Staff Analysis

- Agenda Item: **4.B**
- Proposal: **Application for preliminary site plan approval for the Lake Point Lodge - an apartment building, club house and associated improvements on 5.02 acres, more or less.**

- Case No: PZ15-03
- Applicant: KGH Building Group LLC
- Owners: SKG, LLC
- Parcel # (s): 20-7.0-26-100-003-012.001, 20-7.0-26-100-003-012.002 and 20-7.0-26-100-003-013.000.

A PROPOSED DEVELOPMENT
in
PARKVILLE, MO

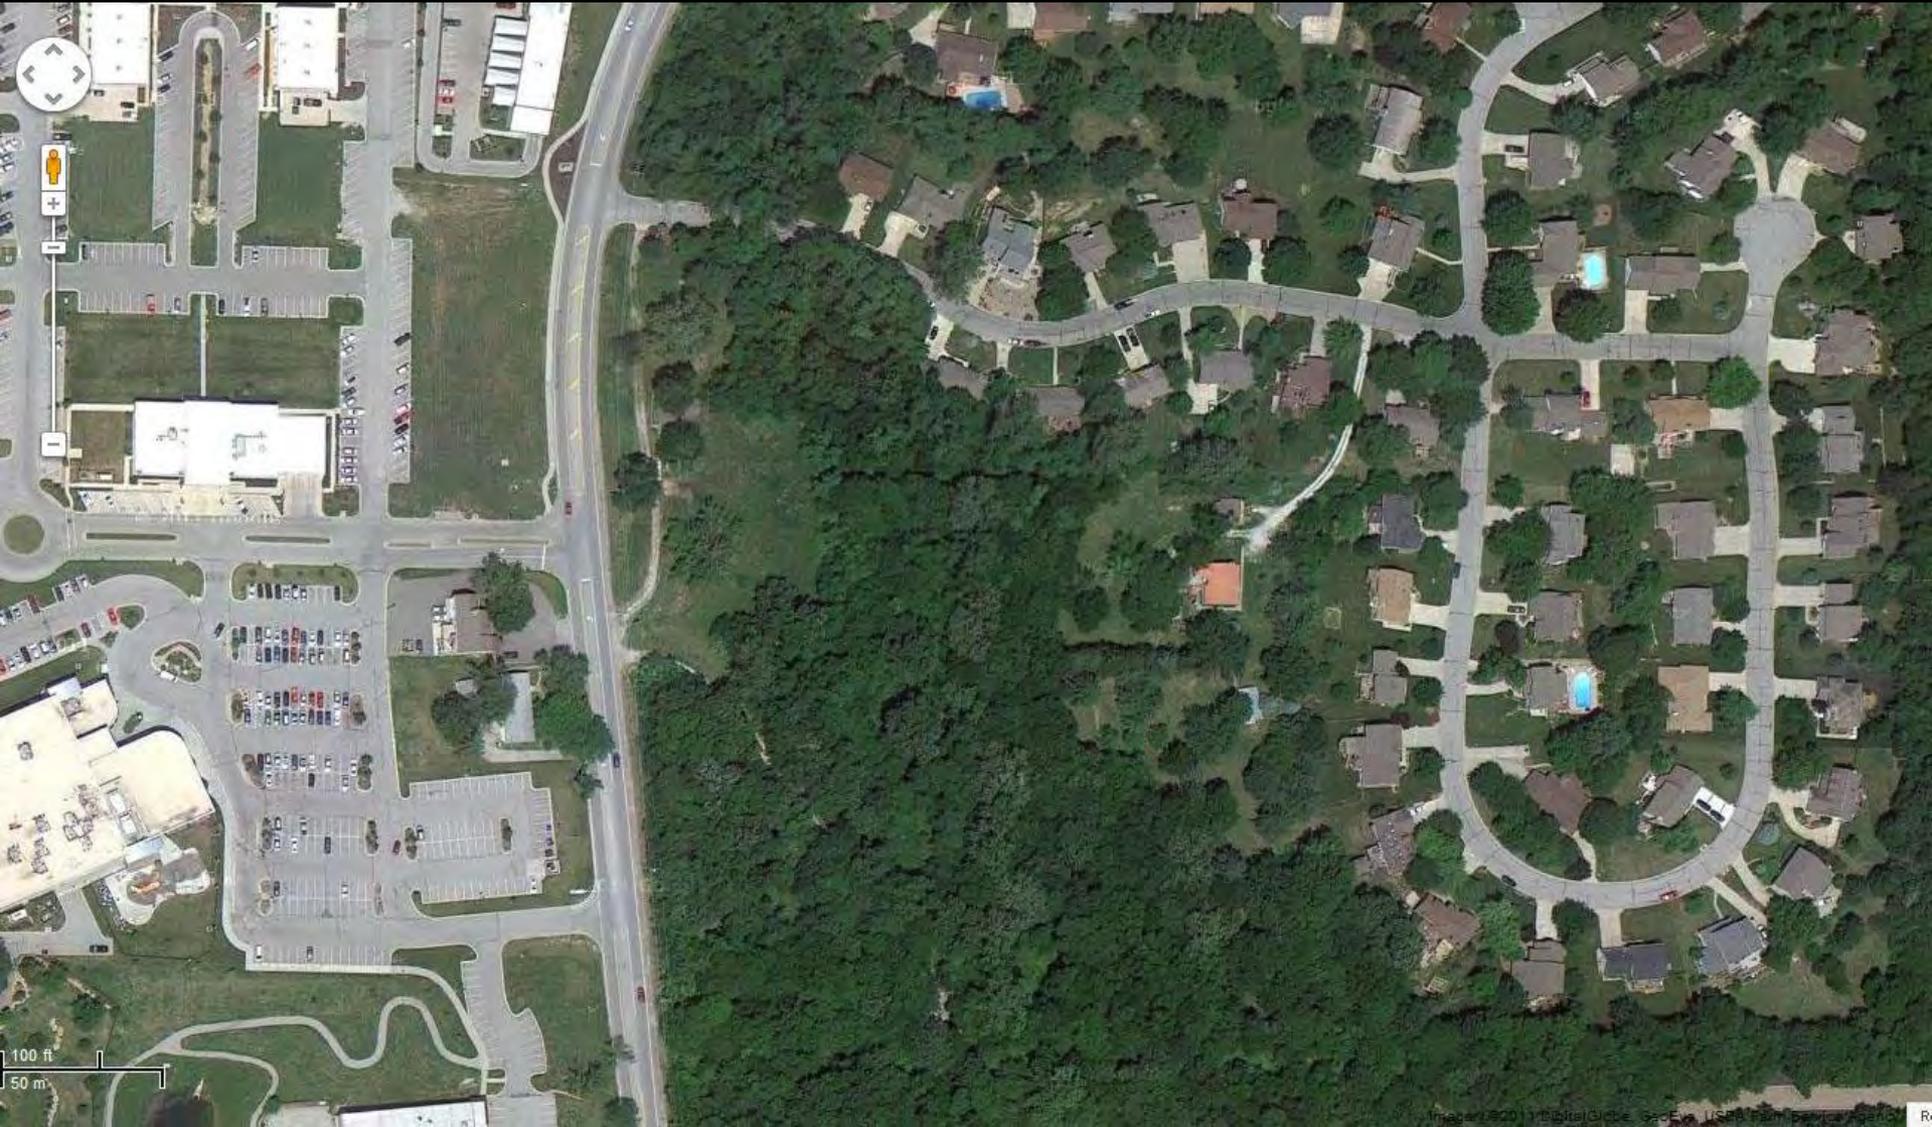
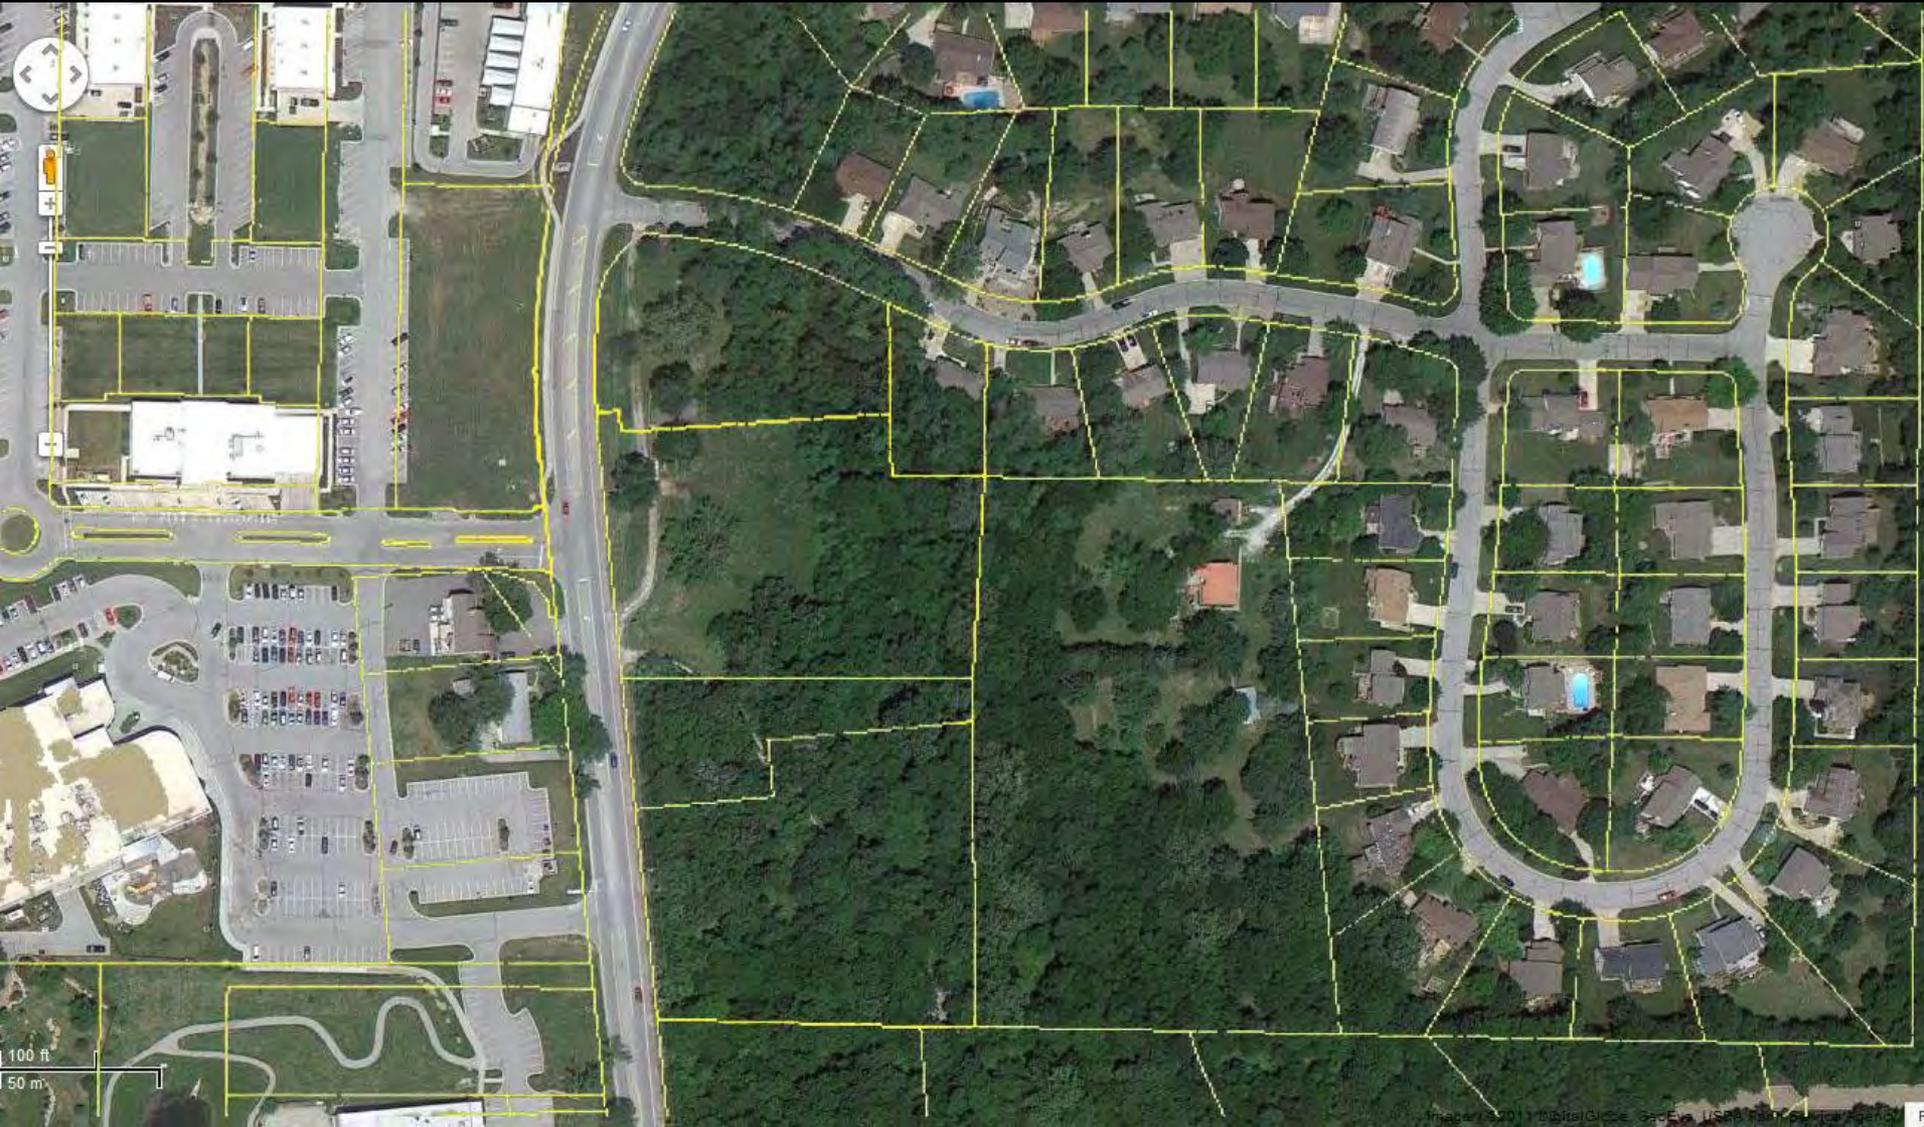
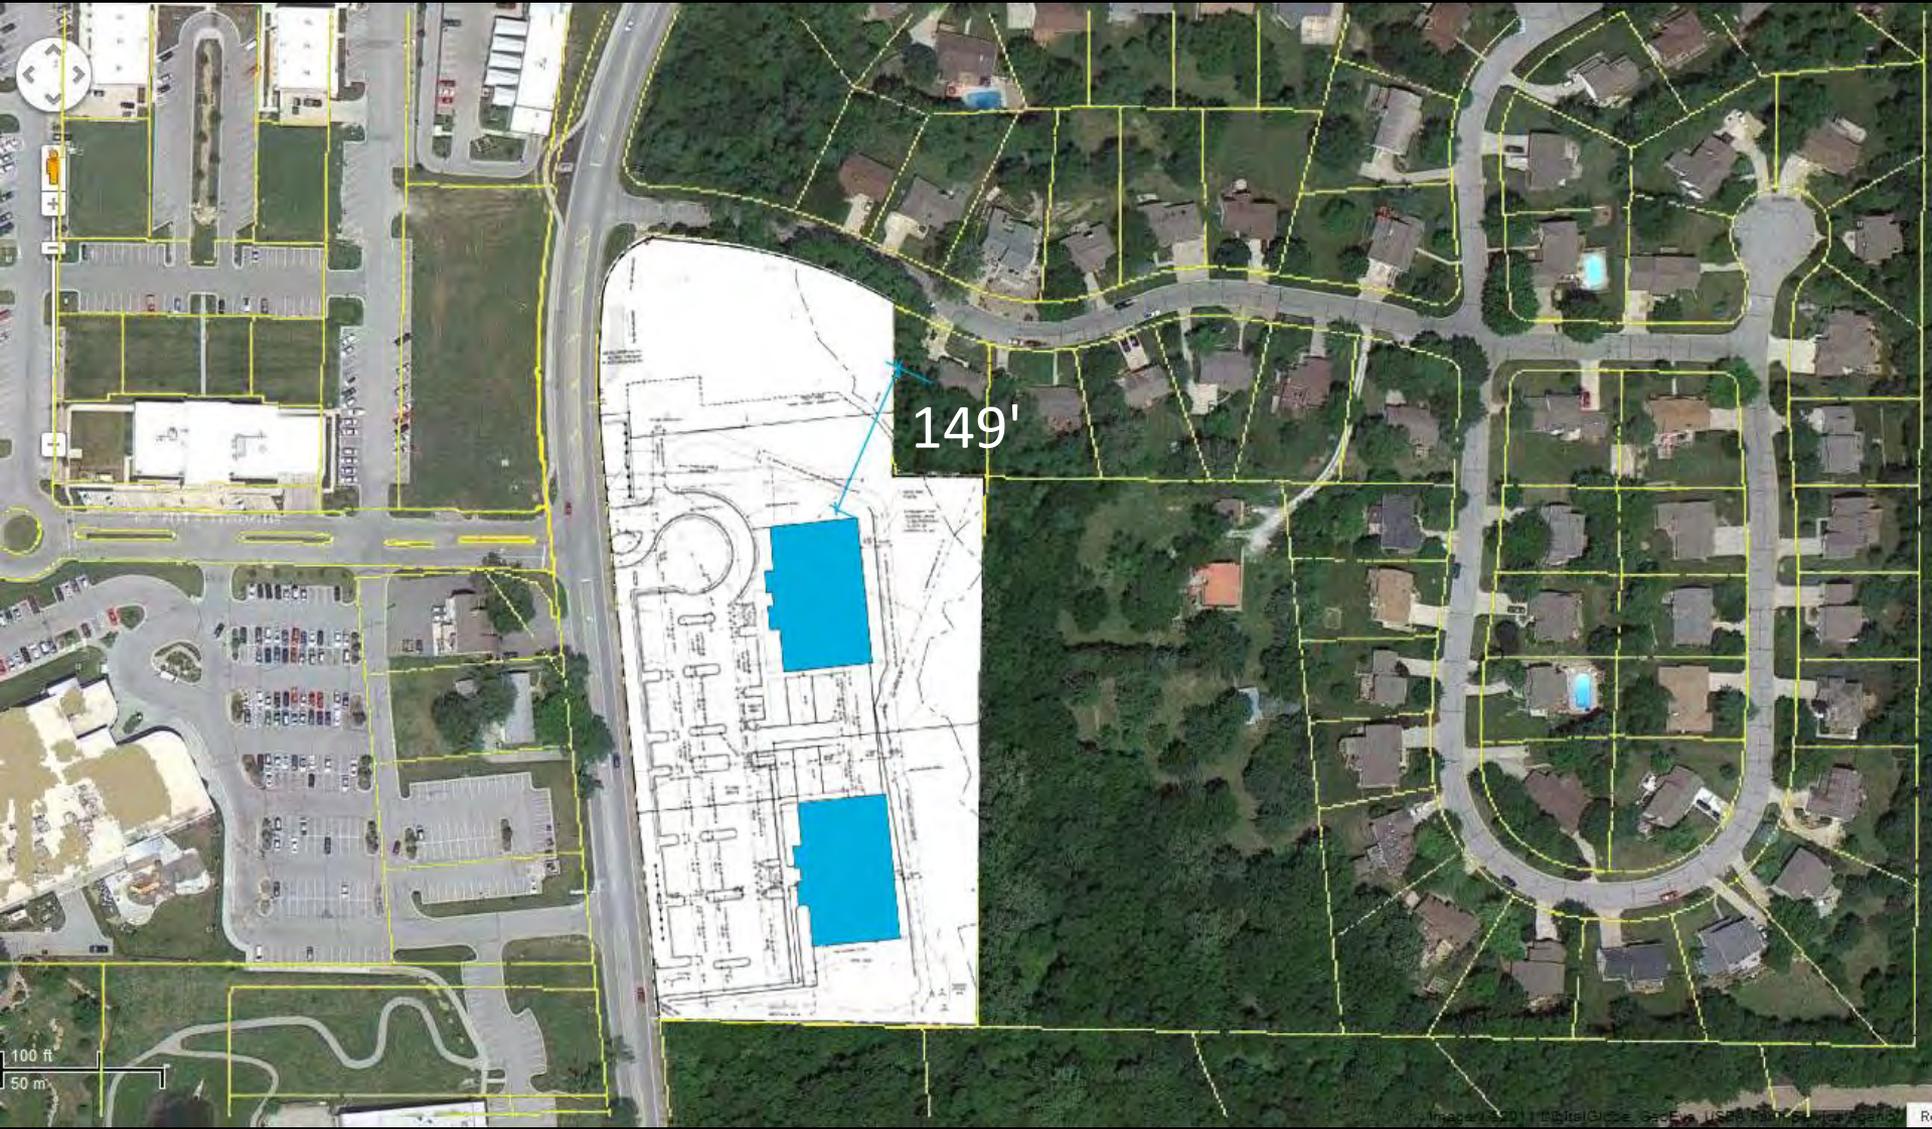
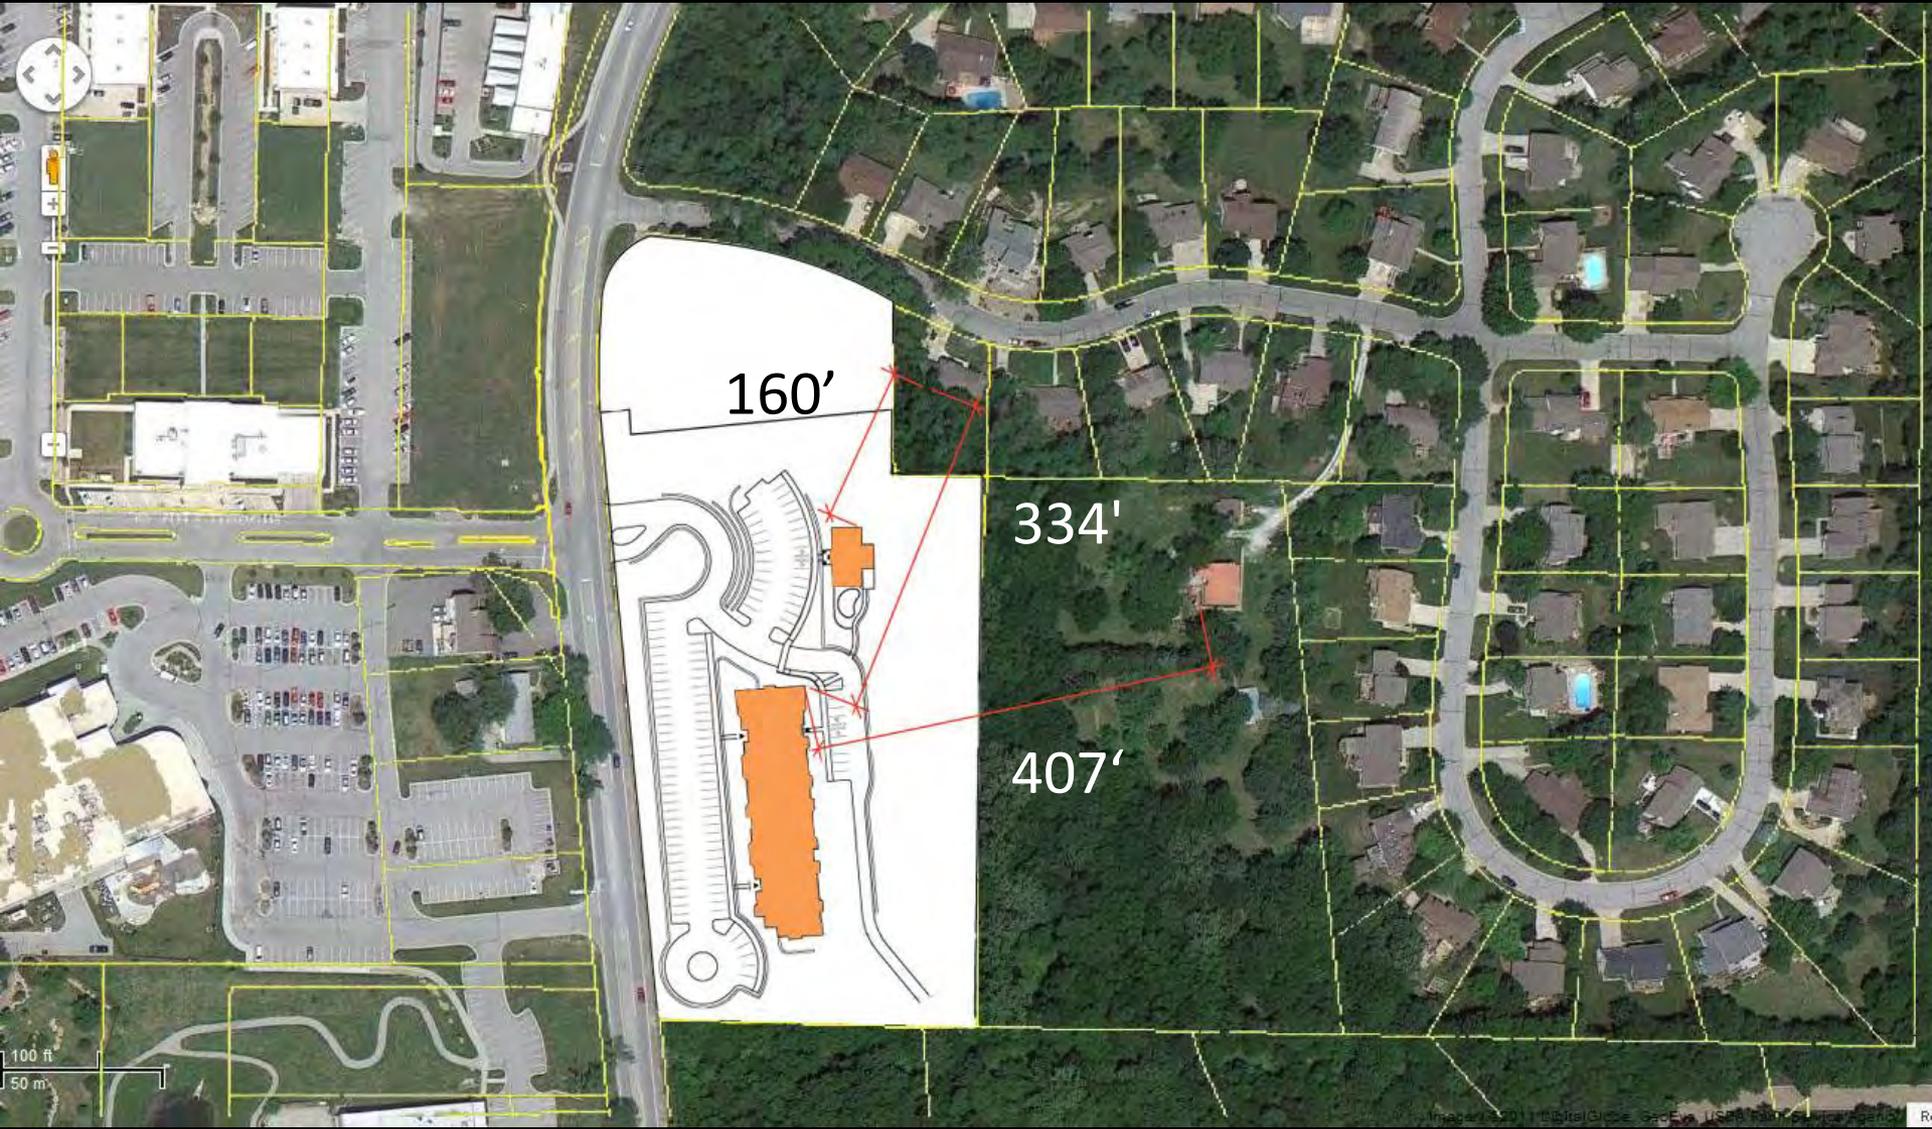
The applicant has also provided drawings comparing the previously approved site plan to the proposed site plan. The plans demonstrate that the proposed apartment building reduces the lot coverage, increases the open space and vegetation preserved, and has less massing than the previously approved office buildings. They also provide sample views from the nearest abutting residential property to the northeast and from 9 Highway (looking northeast toward the proposed building).
